Technical product information

Topic	Sun roof rattle and or creak
Market area	Bentley: worldwide (2WBE),Hongkong-Macau (5HK)
Brand	Bentley
Transaction No.	2045605/1
Level	EH
Status	Approval
Release date

Bentayga

Figure 1

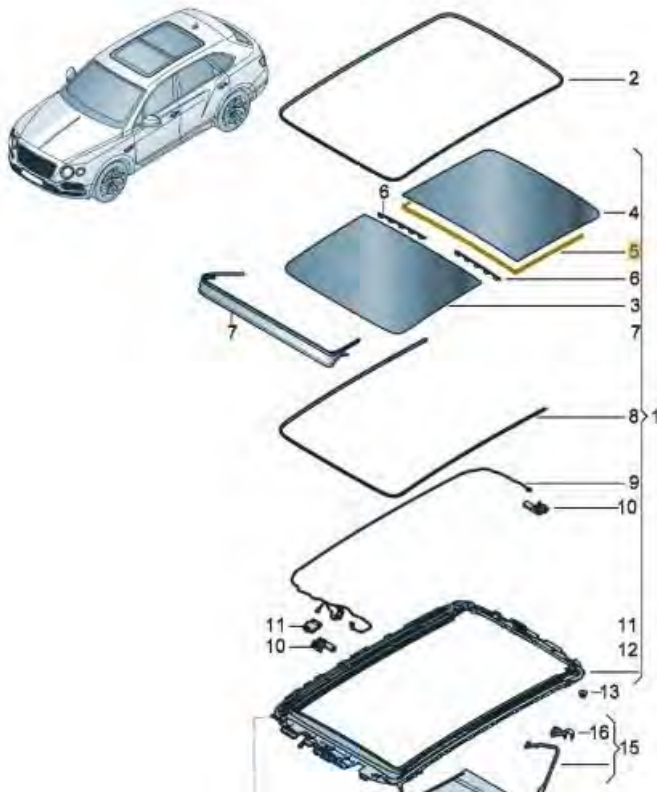
Noise rattle creak in cabin/ sun roof area

New surface finish on seal to eliminate rattle/creak from sun roof

New seal fitted from VIN SJAAB1ZV4HC012697

In the event of a qualified complaint of rattle or creak from sun roof area, in the vicinity of the rear glass inner seal, then replace the original seal (item 5 figure 1) part number 4M0877297 with replacement seal 4M0877297A

Refer to workshop manual Sun roof glazing to remove and fit Rep. Gr 60
